No. 2009
ATA Code 32-30

Kit No. 76-8005-1 S

SUBJECT: LANDING GEAR - INSPECTION OF NOSE LANDING GEAR ATTACH BOLTS AND INSTALLATION OF BUSHINGS

Service Bulletin No. 2009

ONE SIDE SHOWN. BOTH SIDES ASSEMBLED IN THE SAME MANNER

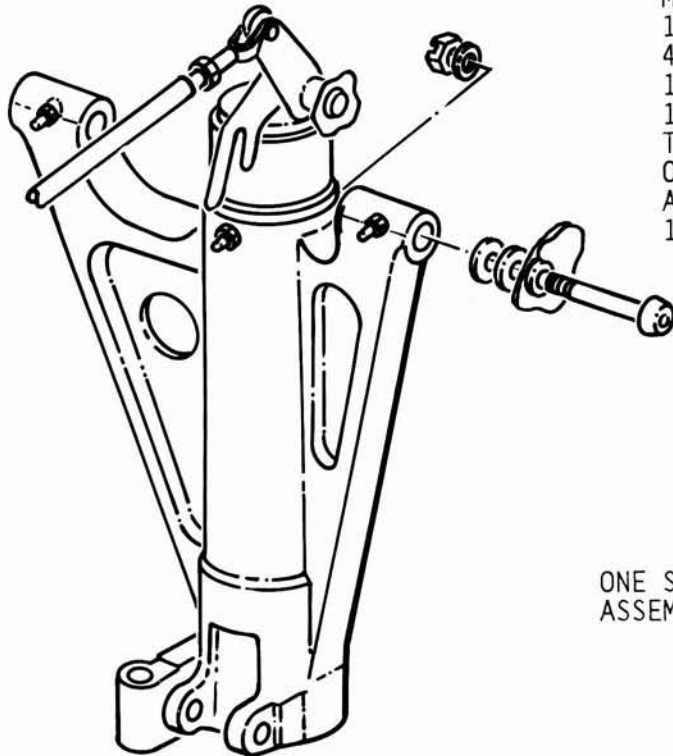
- MS20006-35 /M/ BOLT
- 105-410000-295 BUSHING (UNDER HEAD)
- 45-825011 BUSHING
- 100951S032YP WASHER
- 100951S016YP WASHER (AS REQUIRED TO OBTAIN A TOTAL END CLEARANCE OF .001 to .017 INCH)
- AN960-616 WASHER (UNDER NUT)
- 130909N25 NUT

4. Carefully ream the pivot bolt holes in the left and right keels to .6250 to .6260 inch and chamfer the outboard side of the keels at a 45° angle and to a depth of .02 inch. Deburr the chamfered edges of the holes.

5. Clean the P/N 105-410000-295 flanged bushings with methyl ethyl ketone or equivalent and coat the P/N 105-410000-295 bushings with LOCTITE RC/601. Press the bushings into the pivot holes with the flanged side on the outboard side of the keel.

8. Refer to the illustration and install the P/N 100951S032YP or P/N 100951S016YP washers to obtain a total end clearance of .001 to .017 inch.

9. Install the P/N MS20006-35 /M/ bolts with the bolt heads outboard of the keels.

10. Install the P/N AN960-616 washers, torque the P/N 130909N25 nuts to 72 to 108 inch-pounds.
